TITEL: Byte av primära flyginstrument

GÄLLER: EC 135 T1 (CPDS), P1 (CPDS) och P2 (CPDS) S/N 0005 till och med 0216 utrustade med SMD45H (Smart Multifunction Display) som primära flyginstrument.

ÅTGÄRD: Utför åtgärder enligt Eurocopter Deutschland Alert Service Bulletin No. EC135-31A-002 revision 2 daterad 15 november, 2001 eller senare utgåva.

- Flight Control– and Navigation Indication System
- Replacement of the Primary Flight Displays (PFD) and / or replacement of the Navigation Displays (ND)

Affixing of placard in accordance with requirements
 Figure 1

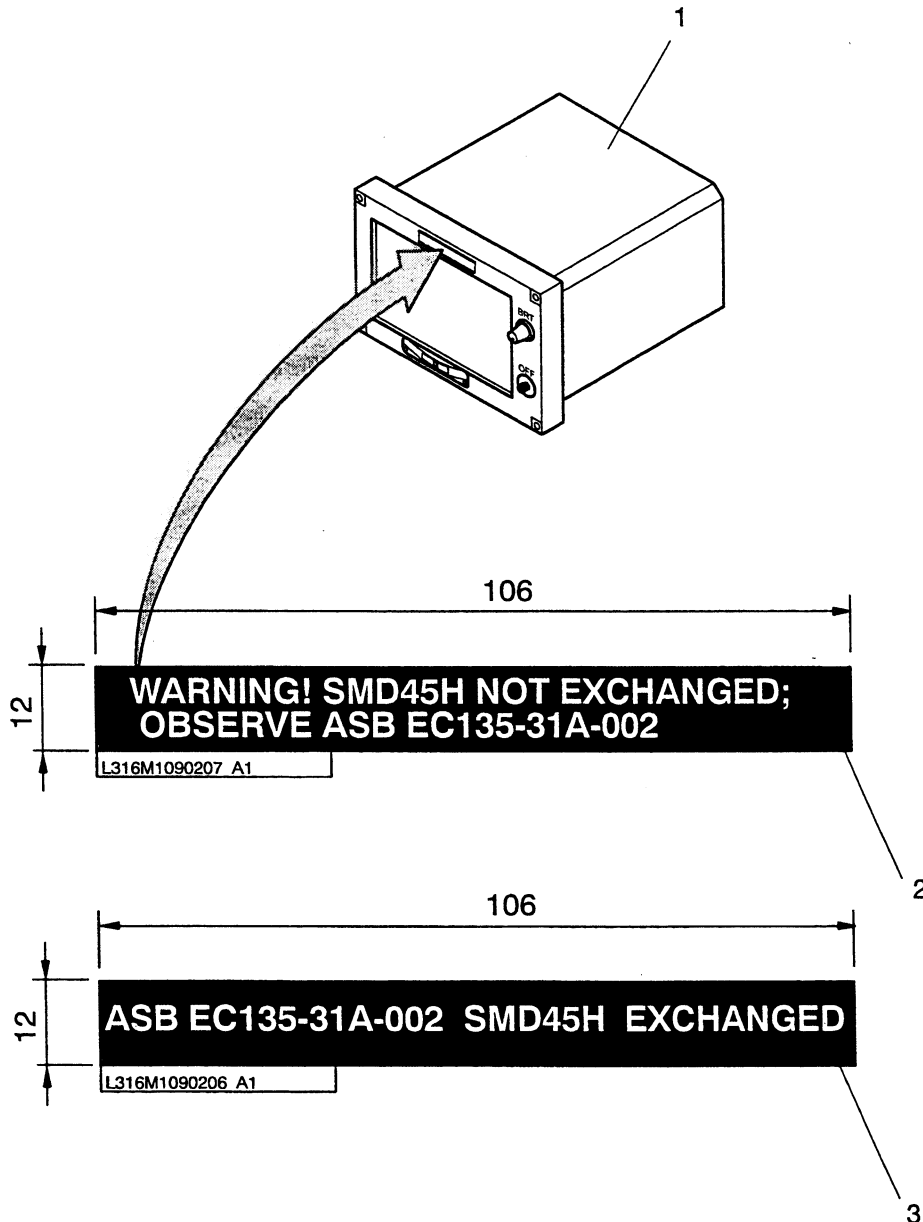
- (c) Using transparent adhesive tape (e.g. sellotape), stick the placard (3) onto the upper edge of the display screen frame of the newly installed SMD45H.

- (a) Using dry cleaning solvent (CM 202), degrease the SMD45H surface (see Figure 1) on which the placard is to be stuck.

- (1) If SMD45H with P/Ns listed in section 1.A.(4) are installed, placard (2) is to be affixed to all affected items of equipment (see Figure 1).

SMD45H are installed in the helicopter with P/Ns listed in "New P/N" column in section 2.C. In this case, placard (3) is to be affixed to the affected item(s) of SMD45H equipment.
